ENGINEERING CHANGE PROPOSAL

ECP NUMBER	TITLE
SJ-M/D-4645	Upgrade Hydraulic System At Sugarland

ECP NUMBER	ECP TITLE	PAGE 1 OF 4
SJ-M/O-4645	**Upgrade Hydraulic System At Sugarland**

CENTRAL HYDRAULIC POWER UNIT

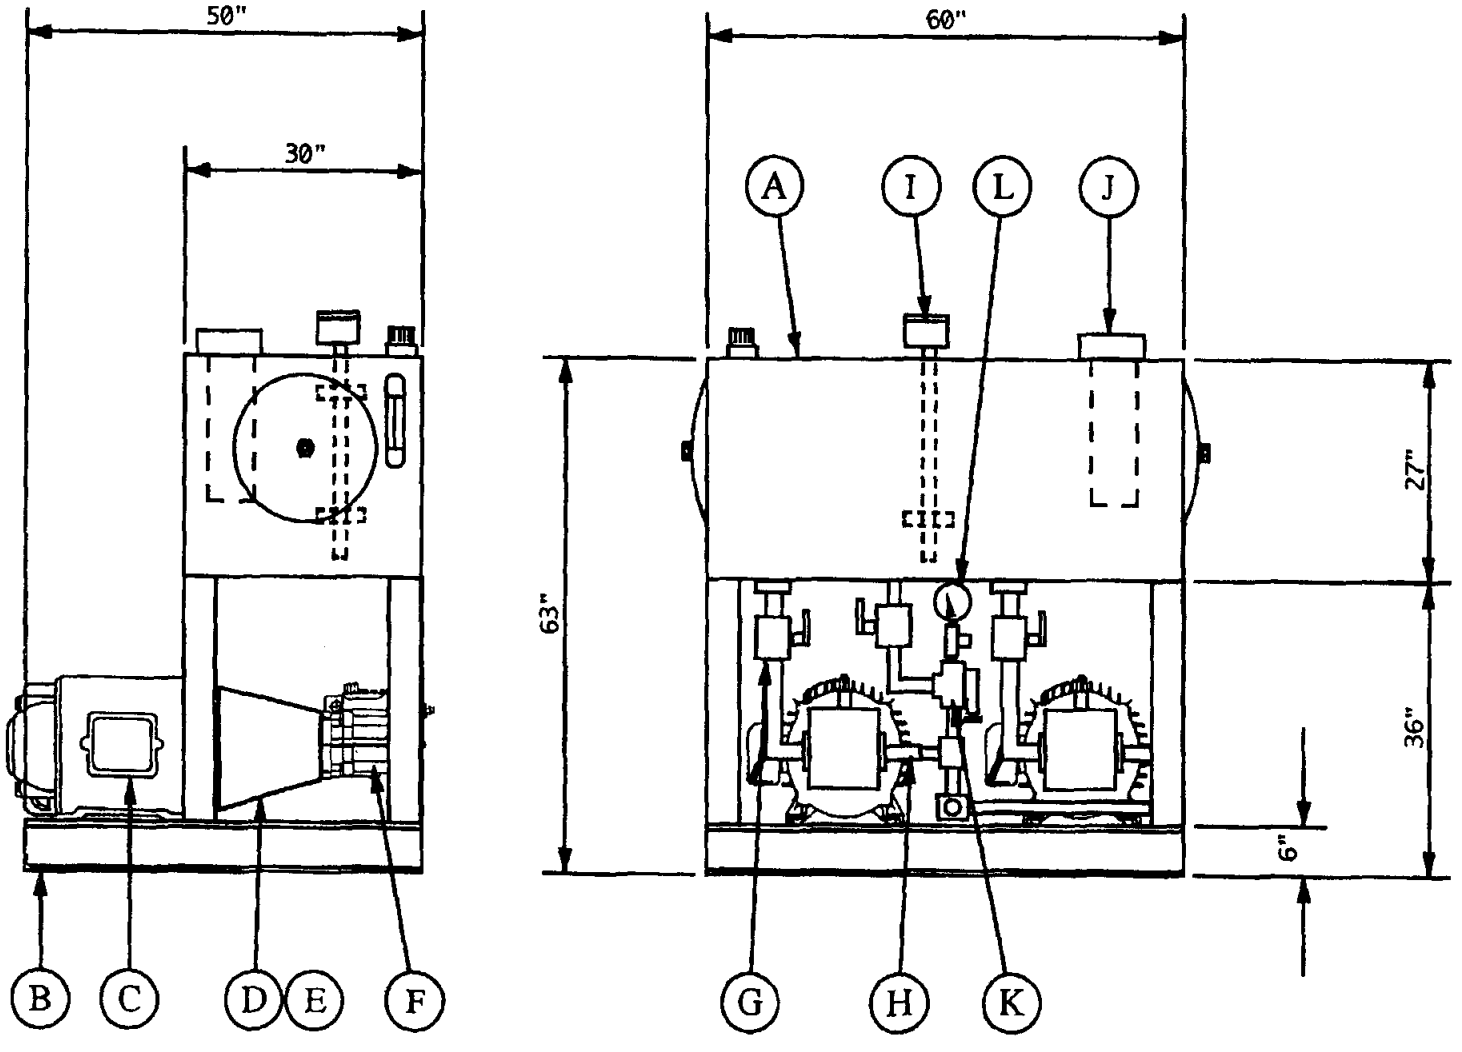
The 10 individual hydraulic units were replaced with a single automated unit for the terminal. See attached parts and installation information.

VALVE CHART
DOE – SUGARLAND TERMINAL

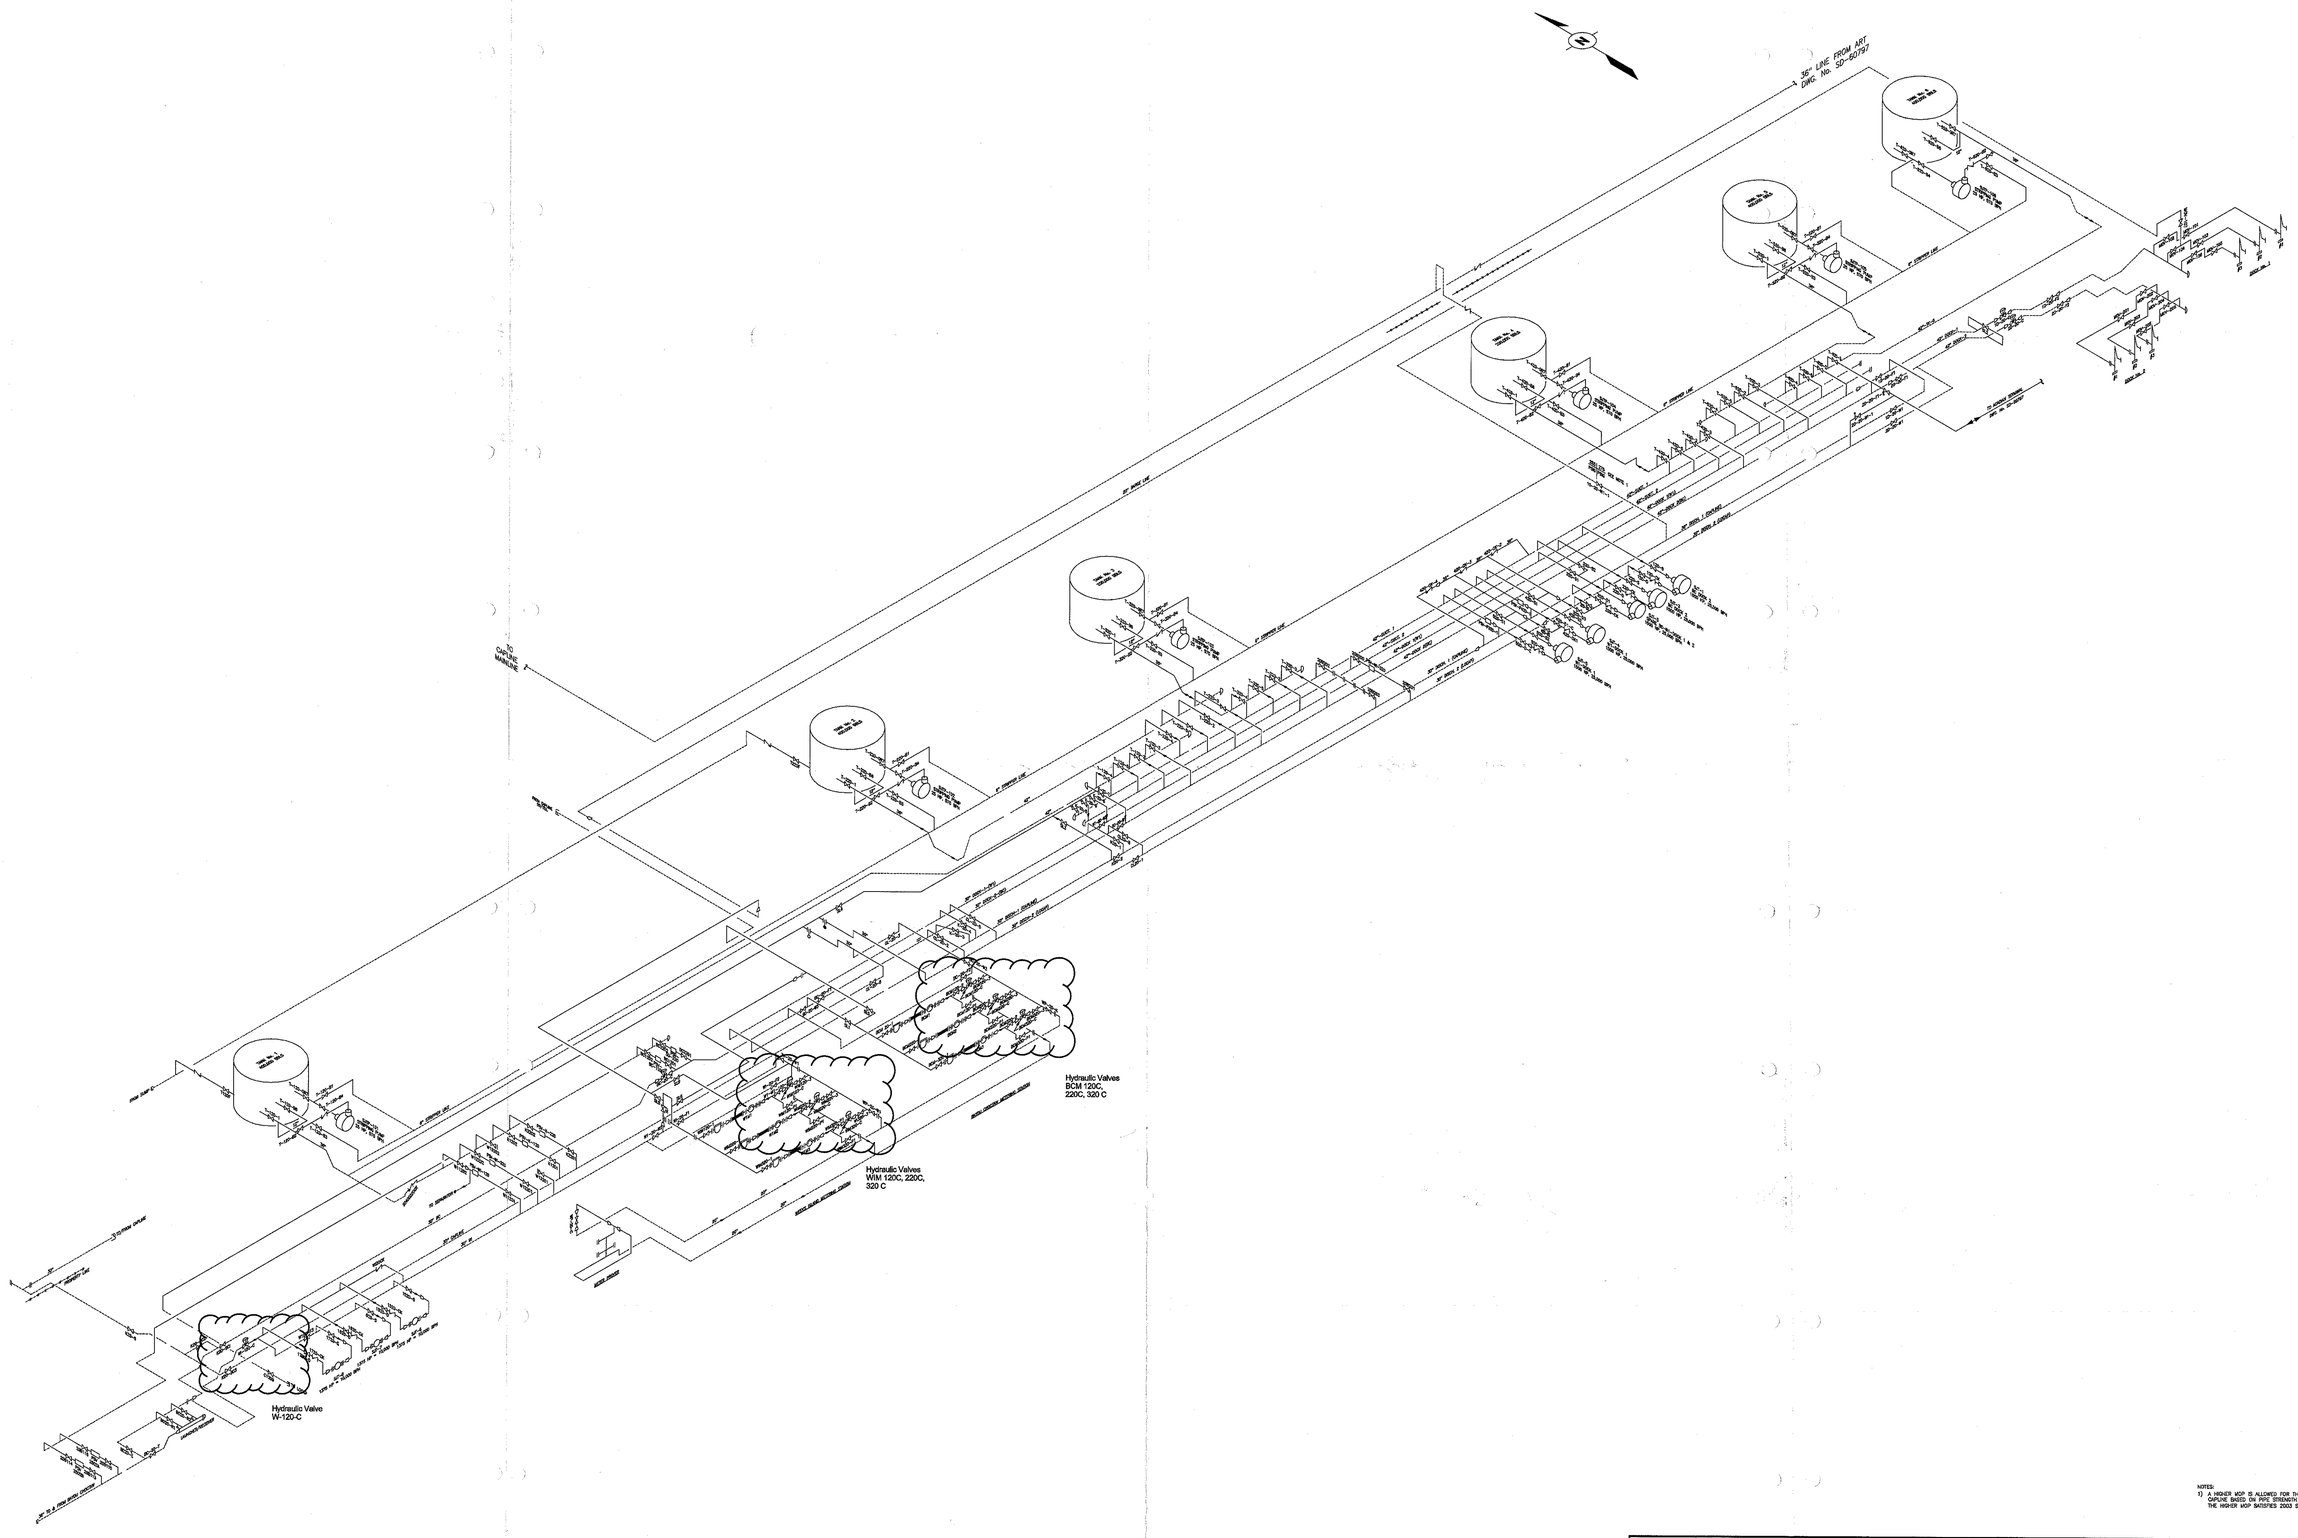
Enclosed please find a Hardcopy drawing #S-32841-06 which highlights the location of the Hydraulic Valve Actuators associated with the ECP for "Upgrade Hydraulic System at Sugarland" The information was requested from Mr. Richard Krebs of Shell Pipeline Company LP on March 8, 2004.

The valves involved in the project include:

BCM 120-C
BCM 220-C
BCM 320-C

WIM 120-C
WIM 220-C
WIM 320-C

WI 120-C

The valve locations are located in the ballooned areas of the drawing.
